Ref: P0754.25

Angel Way Multi-Storey Car park

I refer to the LLFA's response of the 15th of October 2025 in relation to the above project. This letter looks to address the issue raised by the Planning Officer concerning the River Rom naturalisation on site. This submission aims to provide further clarification in order to satisfy the LLFA's concern. Please see our response below. This is broken down in sections to ensure that all issues are addressed:

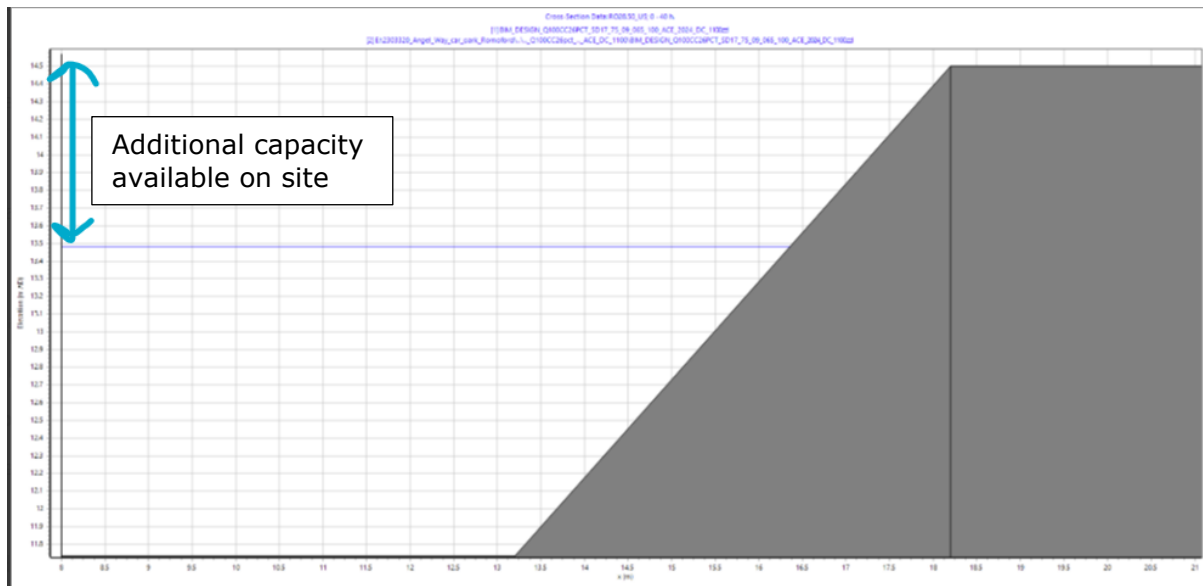
"Binnies are unable to review any revised flood modelling data as it falls outside of their remit, which is not as a consultee but as an independent consultant appointed for the wider River Rom naturalisation aims.

Having said that, and having discussed the proposal with managers within the team, we think it is imperative that the proposal is revised so that the river can be naturalised and made visible as it runs through the site, and we believe there is a way this can be achieved without increasing flood risk on other sites, by creating additional volume for the river within the scheme, as part of a naturalisation process.

I strongly encourage you to review this element of the scheme."

- 1. Planning Officer's Comment - "We believe there is a way this can be achieved without increasing flood risk on other sites, by creating additional volume for the river within the scheme, as part of a naturalisation process."**

Response - There is enough capacity within the scheme to accommodate model water. The section below shows a cross section through the proposed deculverted part of the site and the predicted water level. As you can see there is capacity within the deculverted section to store more water, but water is not getting through the culvert upstream (immediately to the north of the site).

Therefore, creating additional volume for the river within the scheme will not provide any benefits or decrease flood risk off site.
